# Waterloo Metro Quarter OSD Central Precinct (Building 2)

SSD-79307746

SSDA Response to Submissions

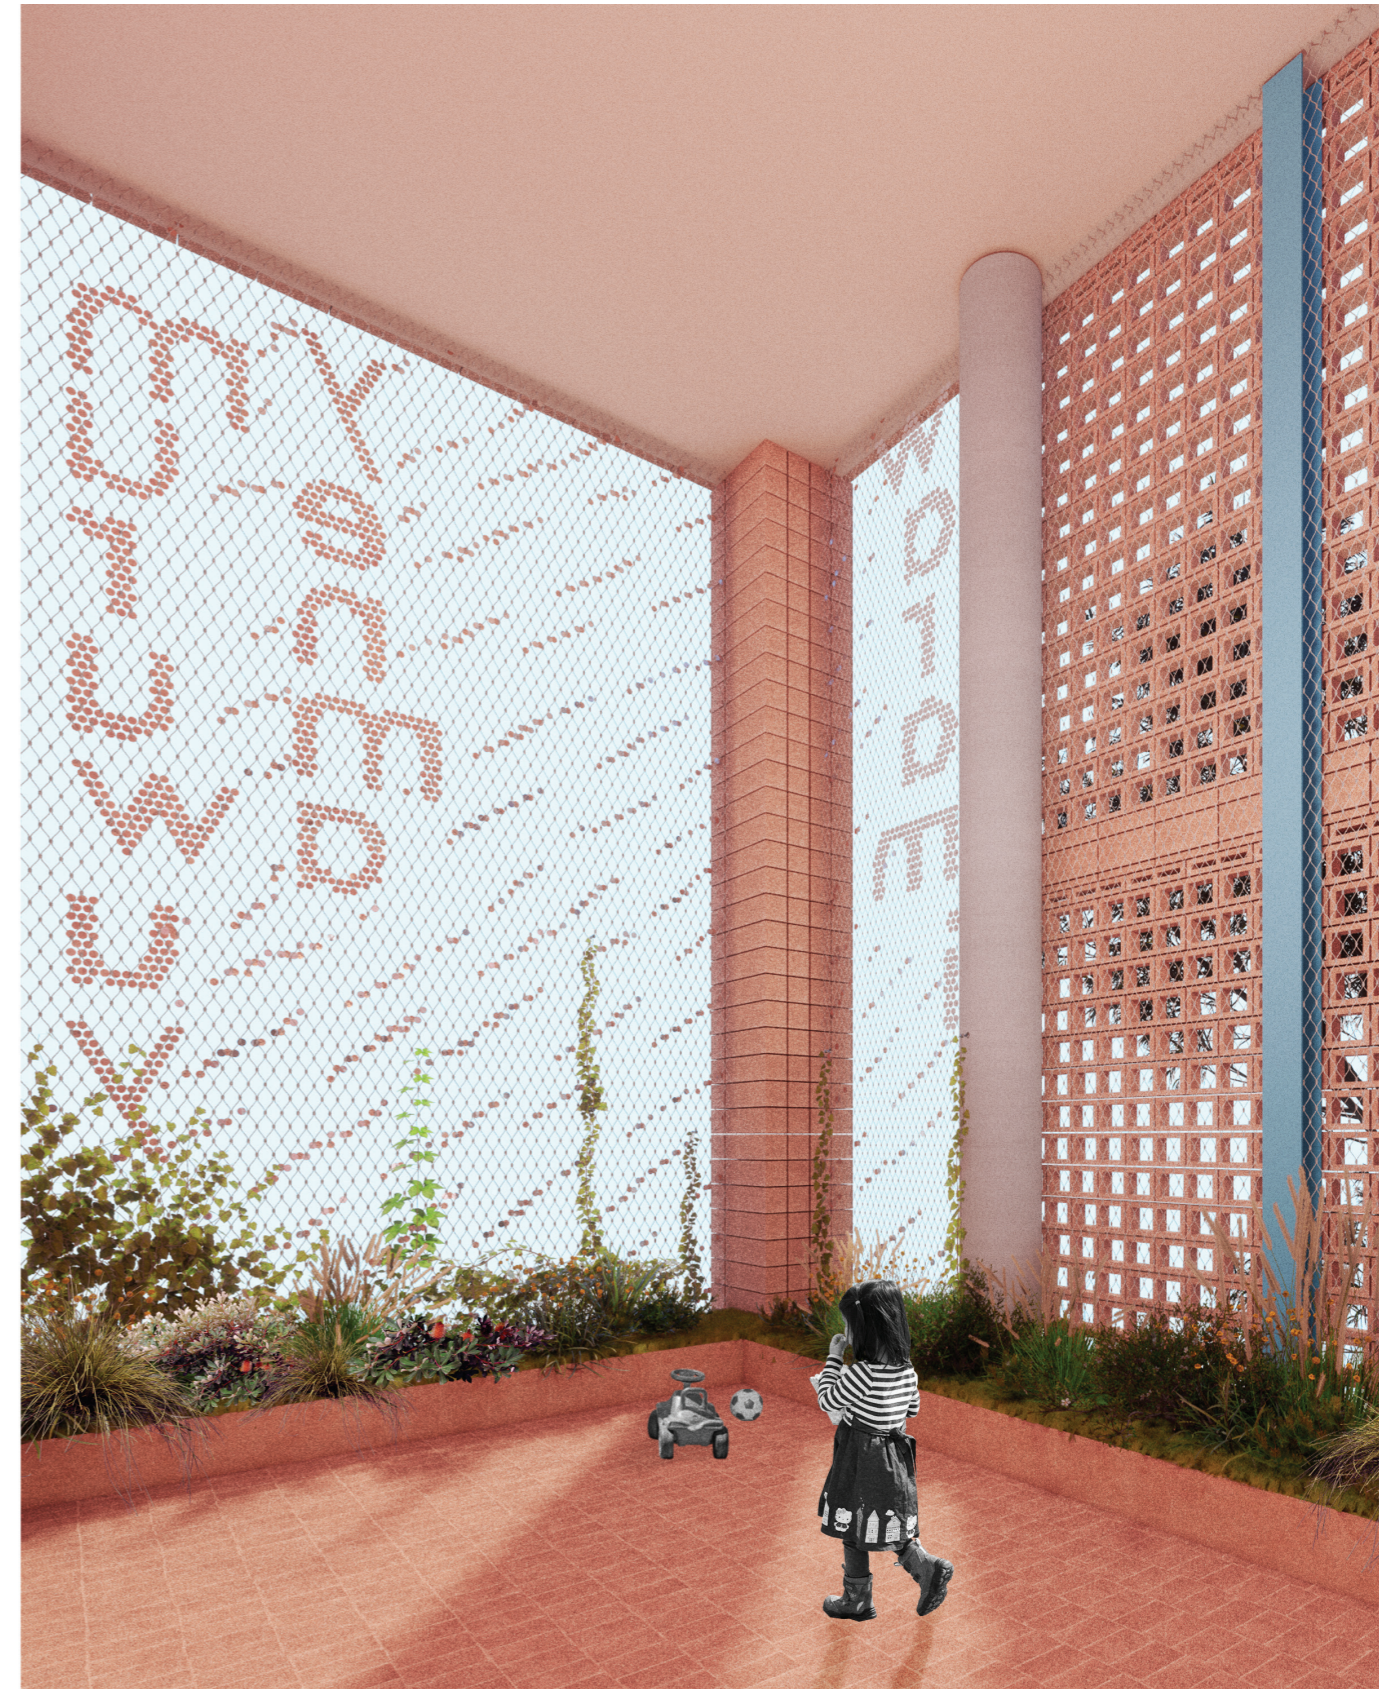
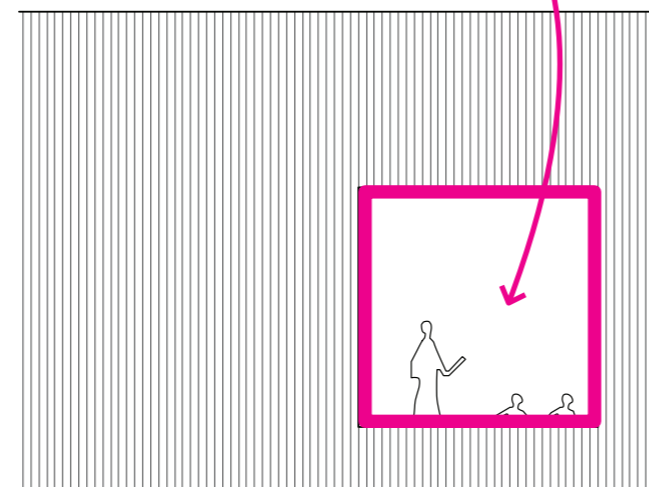
Provide a copy of the site-specific Connecting with Country Guidelines, as prepared by Murawin, including an assessment of the proposal's design response to each of the guiding principles; and

address SDRP's advice on Connecting with Country Point 1: Further exploration of community engagement and empowerment opportunities within the design and operation of the development is encouraged. A document outlining how indigenous business empowerment and co-design will guide the project's design and operation should be developed.

The public art strategy celebrates Gadigal culture, using weaving metaphors, water references, and Indigenous language to inform a unified precinct reflecting Waterloo's history and identity.

The design of the Central Precinct allows for public art opportunities that are integrated or woven into the metal mesh inserts of the childcare facades. The public art is centred around phrases in the Gadigal language that will welcome people to this place. These words draw people in and invite them to feel at home here.

The artwork is highly visible from the public realm and the childcare. The artwork provides a distinctive character to this place, adds interest both up close as well as from a distance, tells stories of this place, provides an education and storytelling opportunity for the childcare facility and public domain experience.

1. Indicative artwork to be further developed with Selected Artist.
2. Artist's references from concept stage proposal.

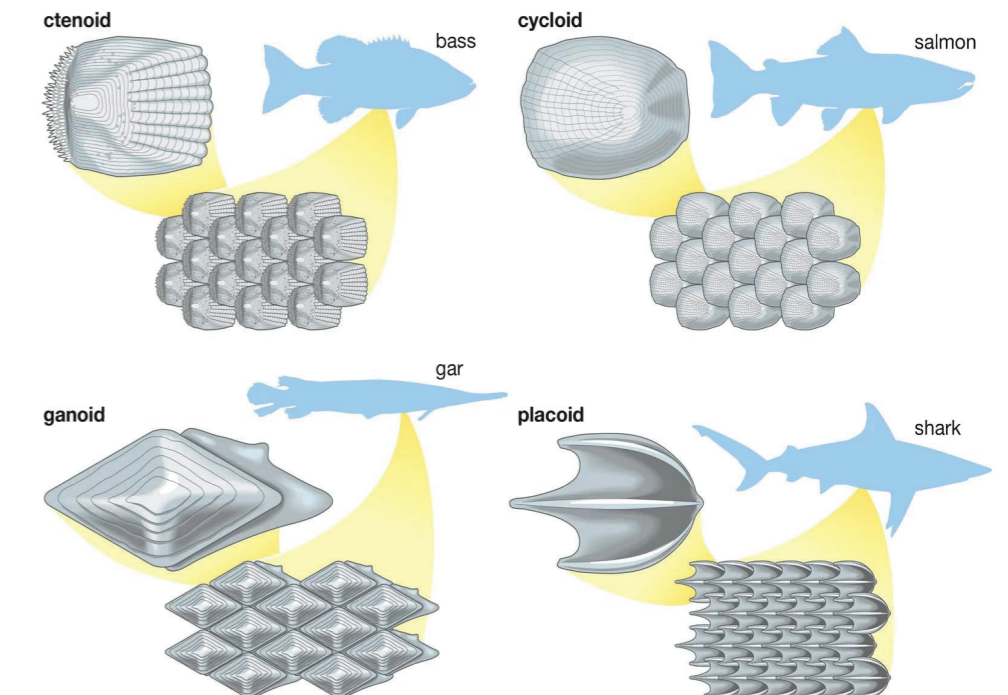
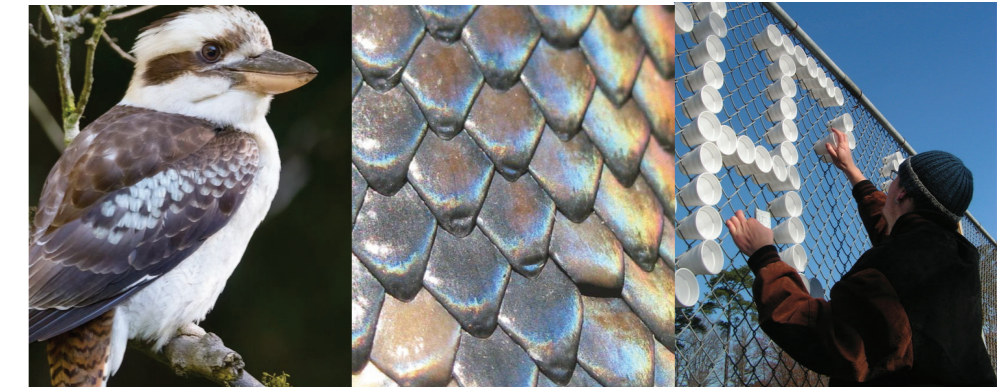
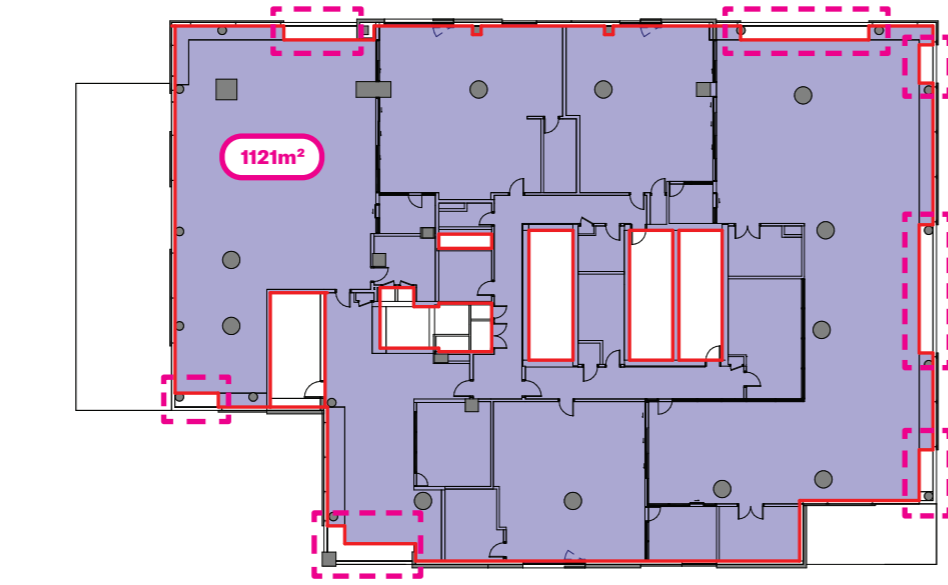
Provide a copy of the site-specific Connecting with Country Guidelines, as prepared by Murawin, including an assessment of the proposal's design response to each of the guiding principles; and

address SDRP's advice on Connecting with Country Point 1: Further exploration of community engagement and empowerment opportunities within the design and operation of the development is encouraged. A document outlining how indigenous business empowerment and co-design will guide the project's design and operation should be developed.

Building on the work outlined in the Detailed Public Art Plan, a public art work is proposed that is integrated or woven into the metal mesh inserts of the Childcare Podium building facades. This artwork will be a two-dimensional design that reflects the designated theme of *Celebrating Country*.

There is an opportunity for the public artwork to incorporate Community Co-design and making, engaging with existing community groups.

The full extent of the artwork and collaboration process is pending further development with the selected artist.

GFA - Level 01 Plan

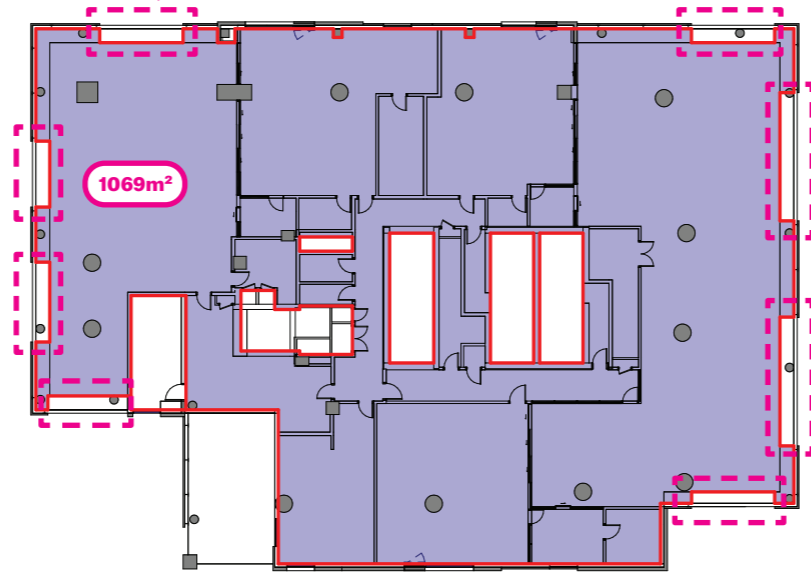
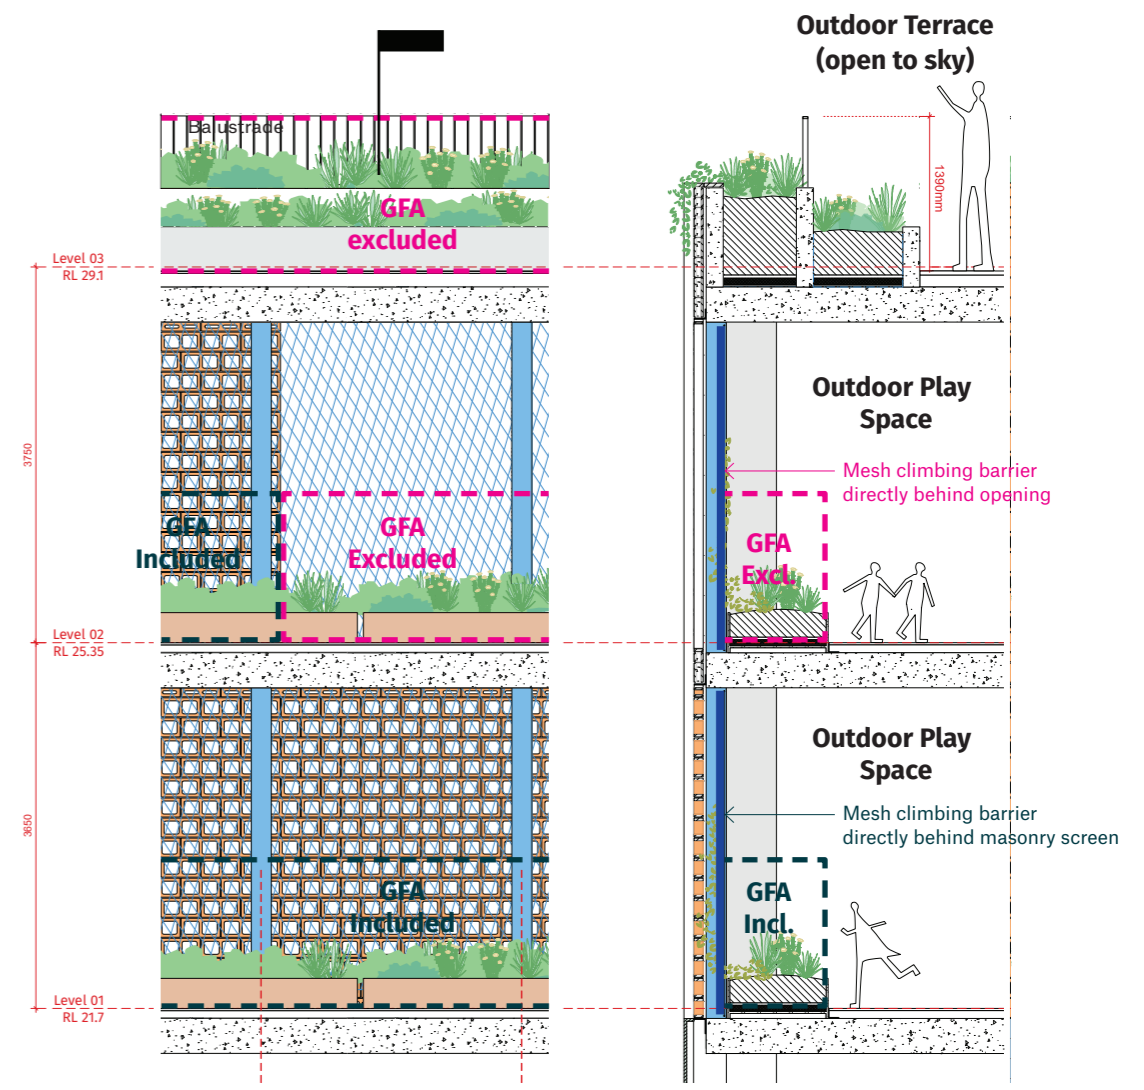
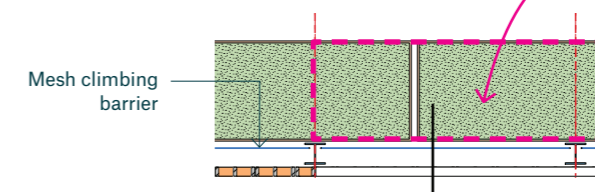
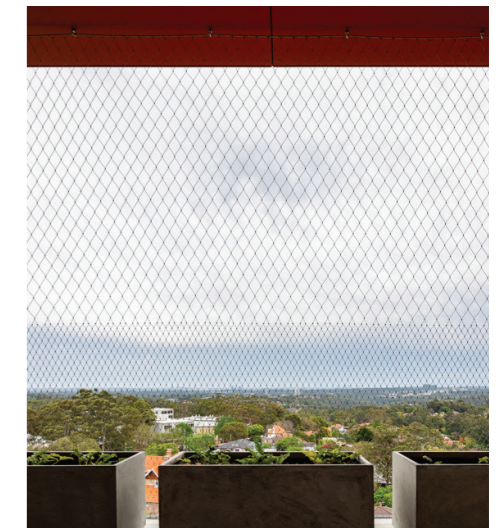
Provide further details, including supporting documentation and drawings to illustrate how the proposal achieves consistency with the maximum gross floor area (GFA) permitted under the Concept Approval .

This must include how the proposed exclusions (such as the Level 1 and 2 Childcare outdoor play areas, and the Level 3 communal areas ) in the Central Precinct meet the definition of GFA under the Sydney Local Environmental Plan 2012 (Sydney LEP).

GFA excludes the planters located directly behind the openings

At levels 1 and 2, the childcare outdoor play area excludes from GFA the planters located directly at the openings. The mesh screen at these openings is largely porous and open to the elements and therefore is considered to be similar to a terrace or balcony condition which would be excluded from GFA calculations.

The mesh screen is provided for fall protection and safety compliance only. In practical terms, these areas remain open to the elements and are not considered the internal face of the external wall. Instead, the GFA measurement is taken from the edge of the non-trafficable planter as would be typical in a terrace or balcony condition.

**View 1 - Street view of mesh screens at outdoor play space openings**

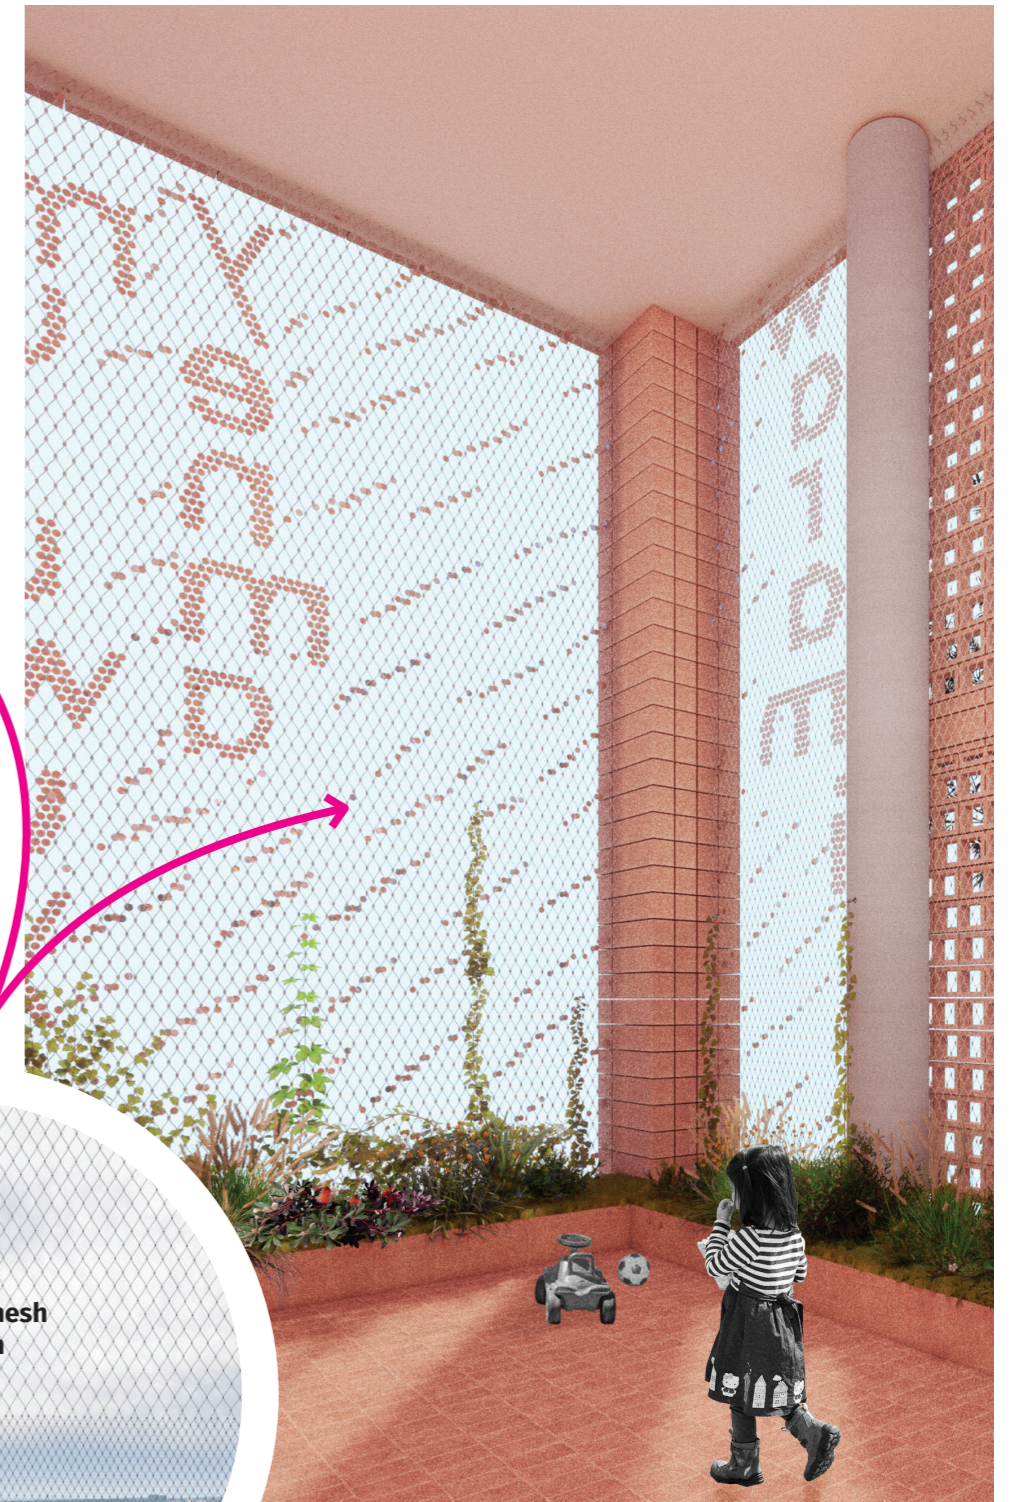
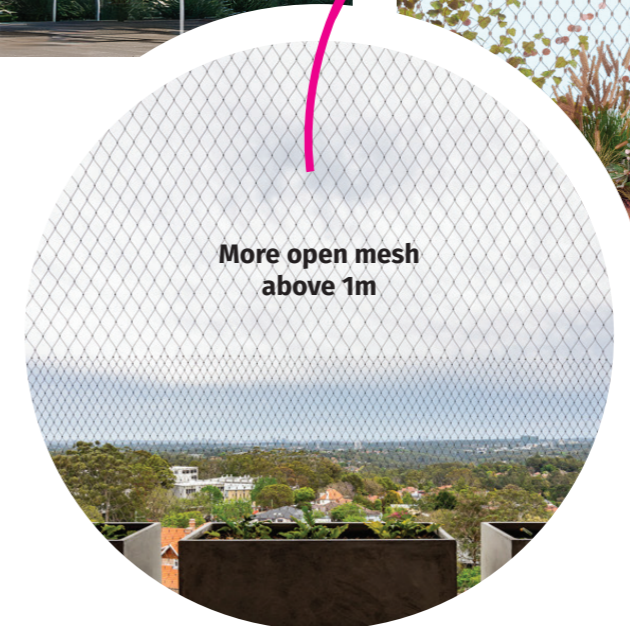
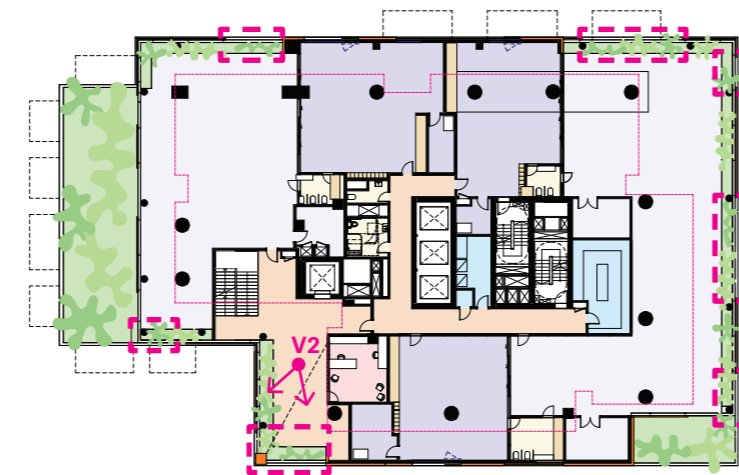
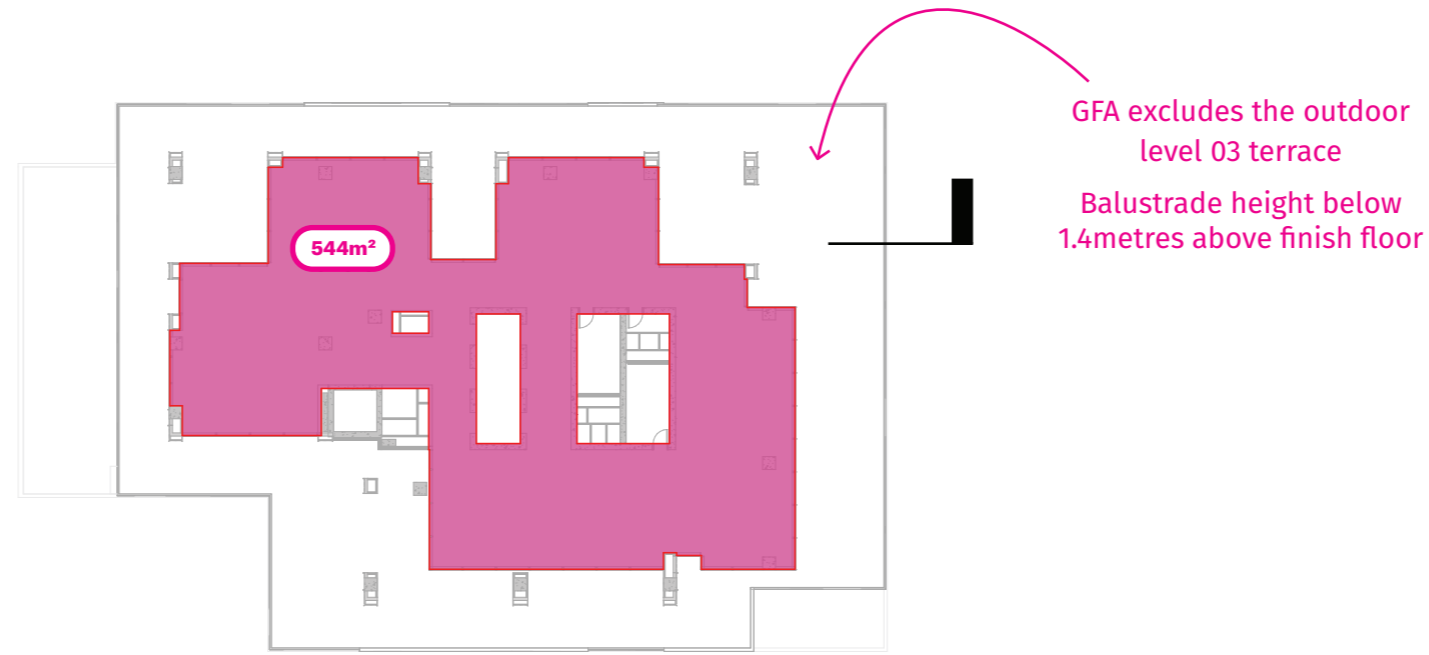
Provide further details, including supporting documentation and drawings to illustrate how the proposal achieves consistency with the maximum gross floor area (GFA) permitted under the Concept Approval .

This must include how the proposed exclusions (such as the Level 1 and 2 Childcare outdoor play areas, and the Level 3 communal areas ) in the Central Precinct meet the definition of GFA under the Sydney Local Environmental Plan 2012 (Sydney LEP).

At levels 1 and 2, the childcare outdoor play area excludes from GFA the planters located directly at the openings. The mesh screen at these openings is largely porous and open to the elements and therefore is considered to be similar to a terrace or balcony condition which would be excluded from GFA calculations.

The mesh screen is provided for fall protection and safety compliance only. In practical terms, these areas remain open to the elements and are not considered the internal face of the external wall. Instead, the GFA measurement is taken from the edge of the non-trafficable planter as would be typical in a terrace or balcony condition.

Planters located at mesh screen openings
